Reference of proposed development No. 504/2007 Property: 68 Birkley Rd

Applicant: Ms G A Coward

We wish to lodge an objection to one particular point in the above DA, that being "existing masonry wall to be demolished and replaced with a timber fence on boundary".

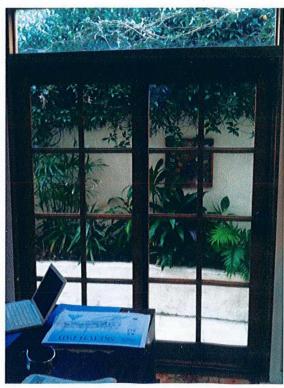
This shared masonry wall is an important feature of our property. The house has been designed with large sliding windows/ doors looking out from the living/dining room to the "wall" which is actually also a garden feature. Further to this, our sandstone paving has been layed around the masonry wall garden bed and if this were to be removed, there would be significant expense in replacing a large section of pavers for continuity.

A further structural concern on the removal of the masonry wall is drainage as number 68 sits approximately a foot higher than our property and whenever there is significant rain, large amounts of water come under the existing timber fence. With the current layout, the majority of water is directed into our specifically designed drains, however if the masonry wall were to be removed, there would potentially be a large amount of water flowing through to our timber foundations unless appropriate drainage was built to redirect this water.

We have attached 2 photographs showing the masonry wall from our perspective with the garden bed, paving and the aspect from inside our house looking out through the sliding door/ windows.
